**RE: Legacy NAA Apartments 2  
Conceptual Grading and Drainage Plan  
Engineer's Stamp Date: 7/16/18  
Hydrology File: C18D083**

Based on the resubmittal received 7/16/2018, the Conceptual Grading and Drainage Plan is approved for action by the DRB on the Site Plan for Building Permit.

LEGACY NAA  
 APARTMENTS II  
 CONCEPTUAL DRAINAGE PLAN

**LEGACY NAA  
APARTMENTS II  
CONCEPTUAL GRADING PLAN**

SHEET NUMBER:  
**C-1**

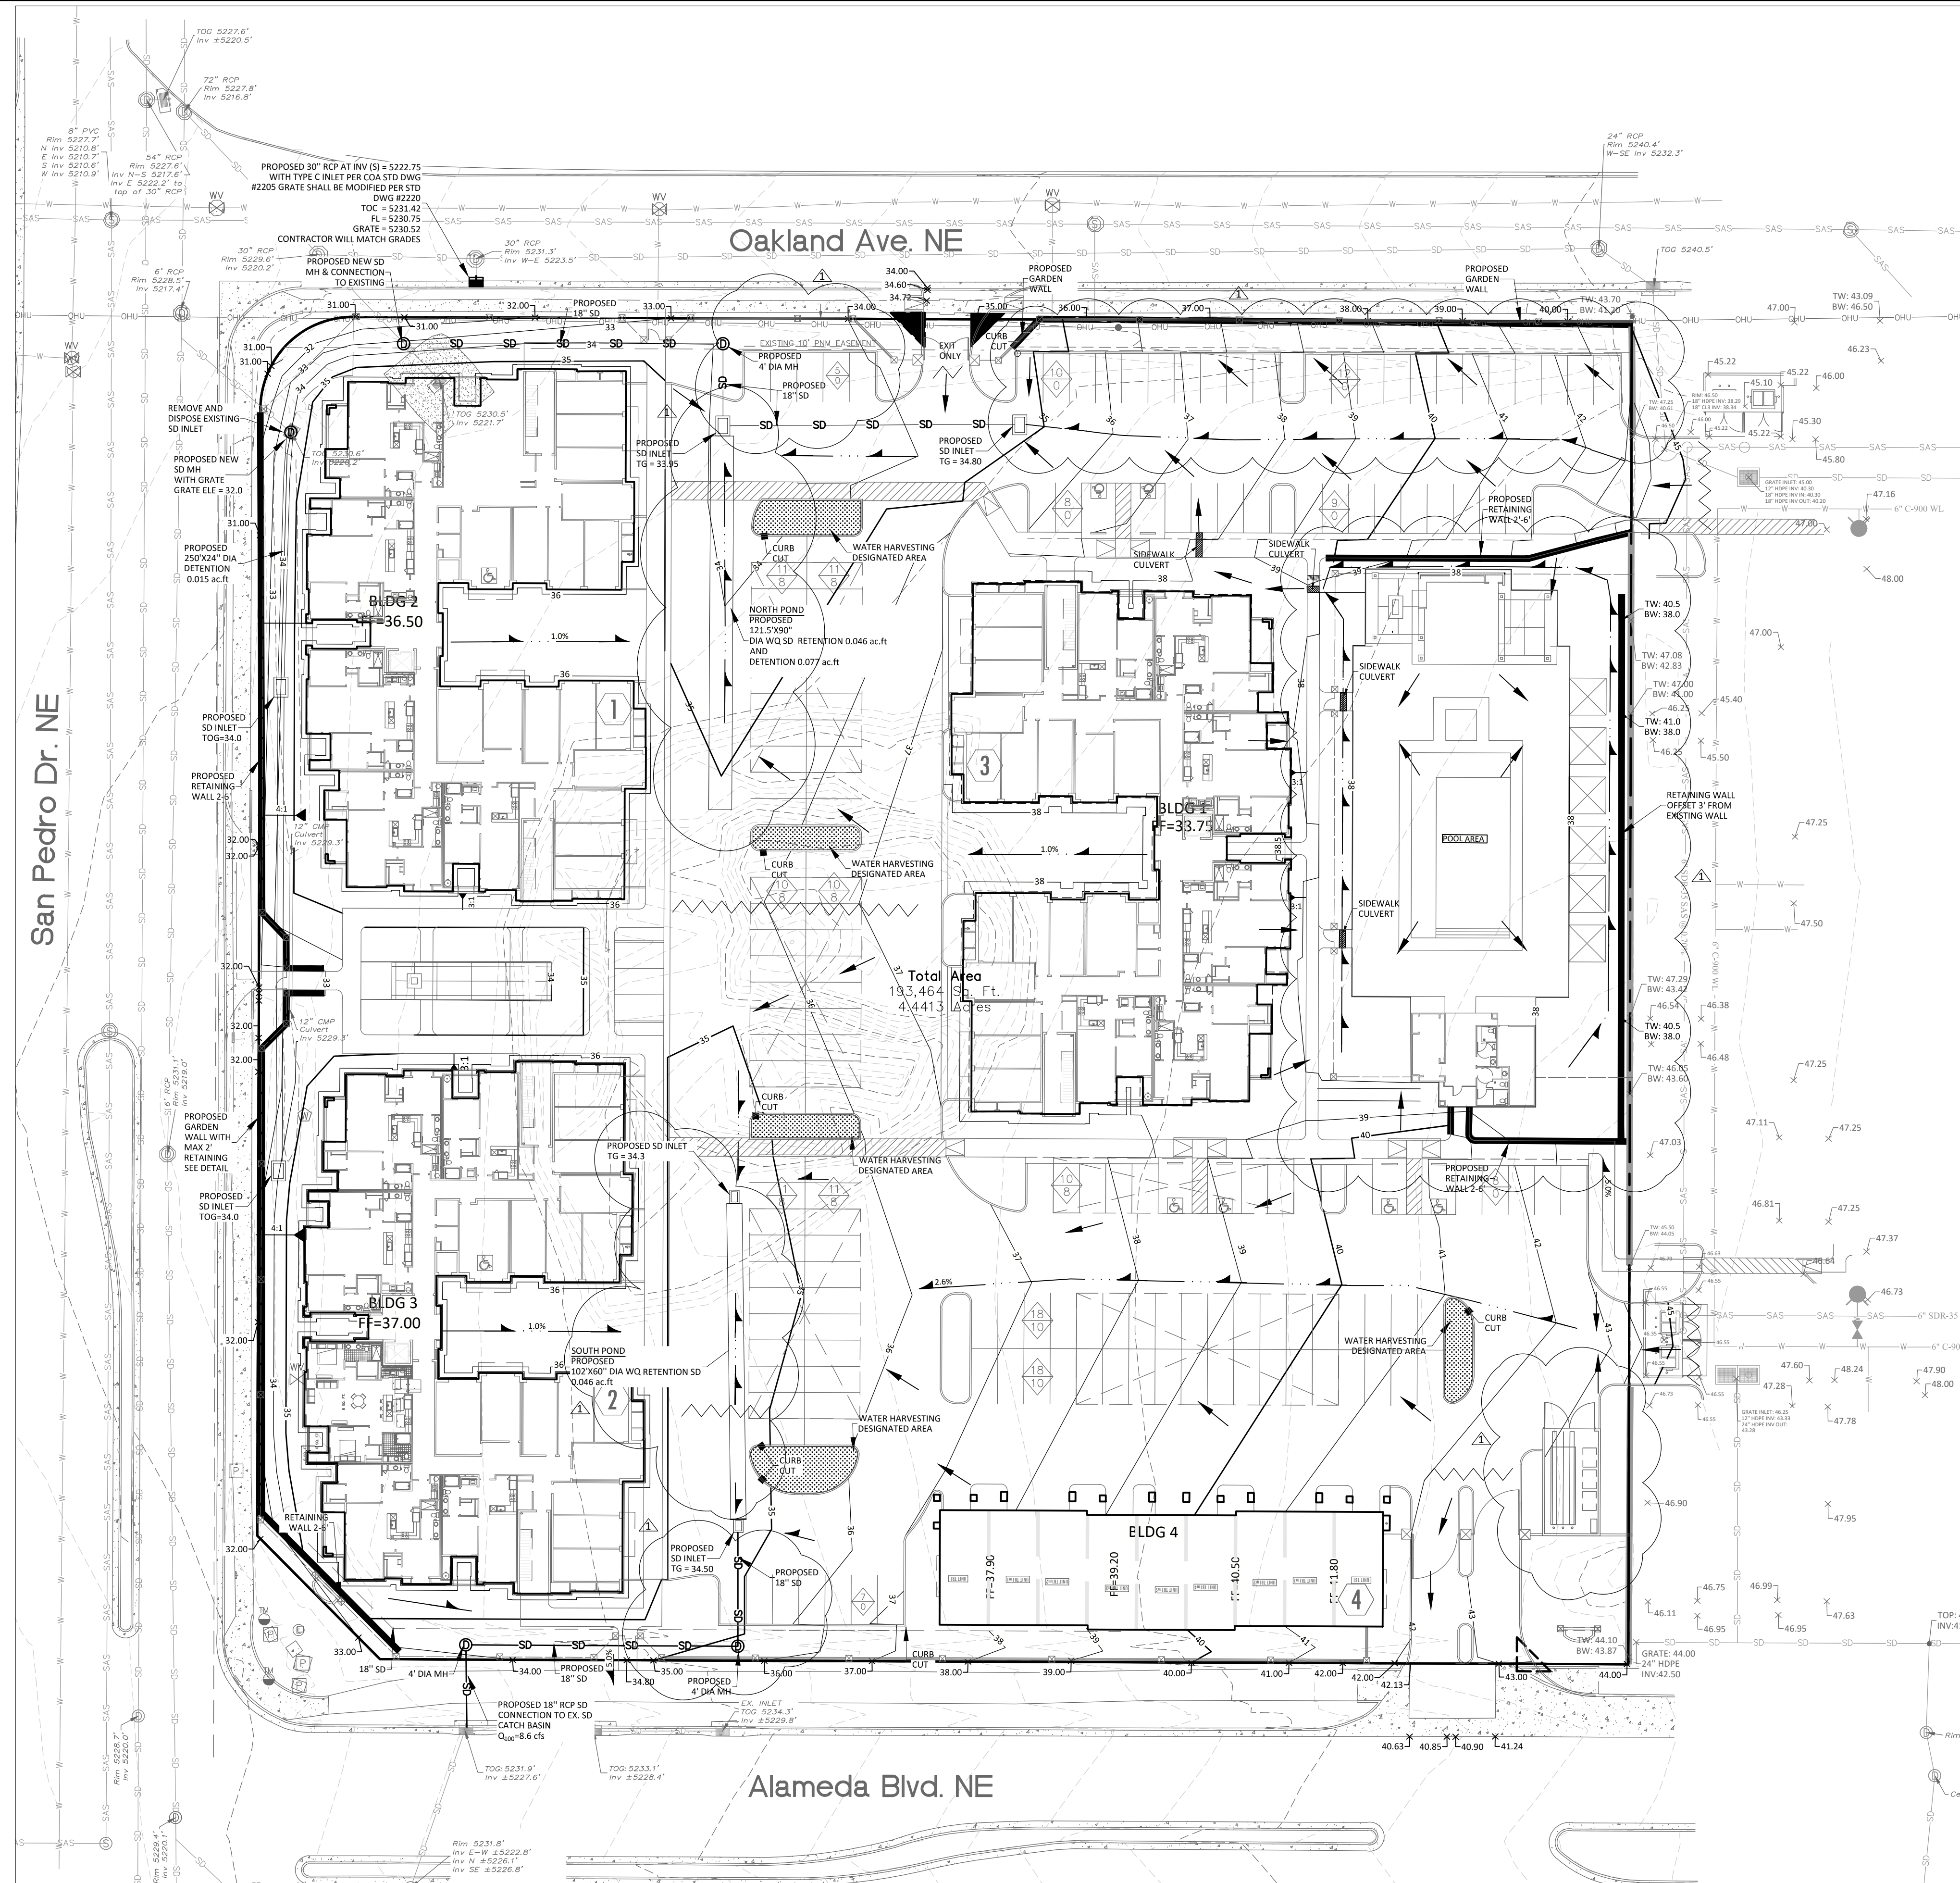
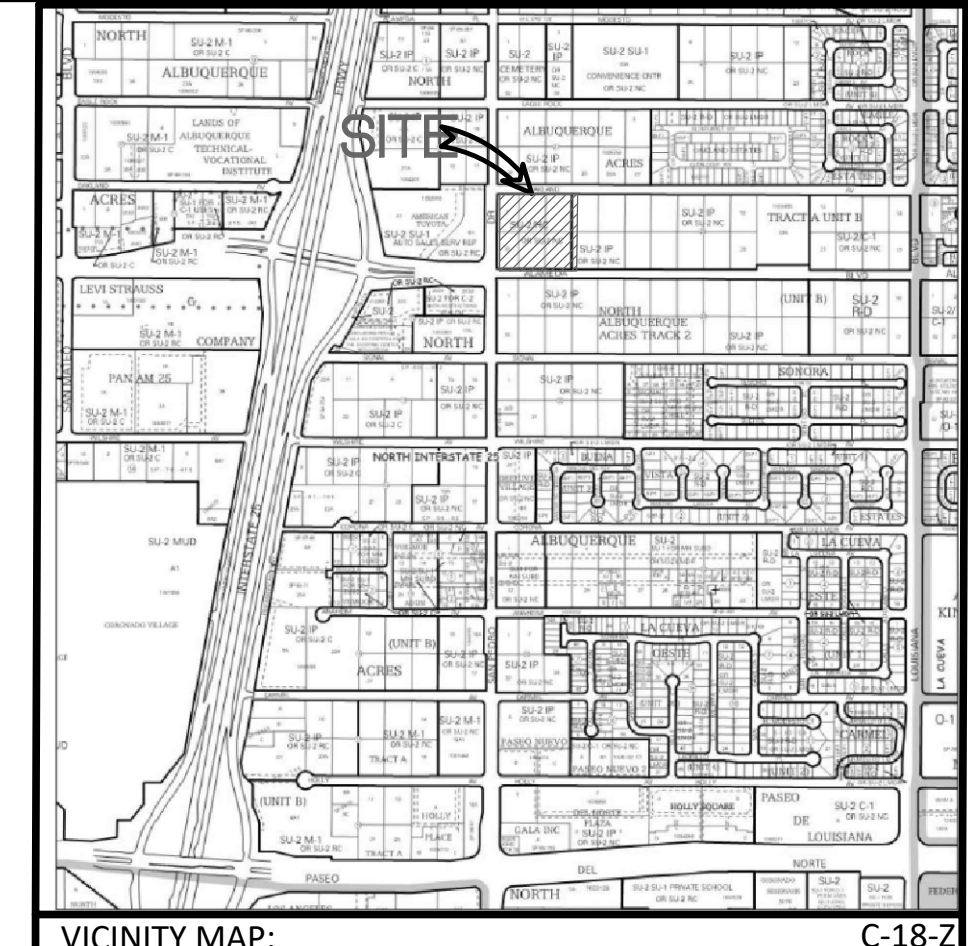
1. Please provide a Private Facility Drainage Covenant per Chapter 17 of the DPM for the first flush ponds and the retention ponds prior to Building Permit approval.
2. Correct the orifice plate size (0.80") and provide its supporting calculations.
3. Additional comments may be provided at Building Permit, based on the outcome of the above remarks and level of detail shown on plans.
